# Product Change Notification

| <b>Date Issued :</b>                              | December 02, 2022                                                                                                                                                                                                                                                                                                                                                                                                                                                                                                                                                                                                                                                                                                                                               | <b>PCN Number :</b> | 513077 |
| <b>Reason for Change :</b>                        | Change Supplier

## ➤ Color difference

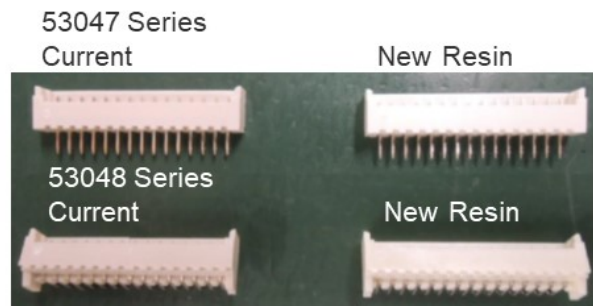
After changing the resin, the color will be slightly brighter.
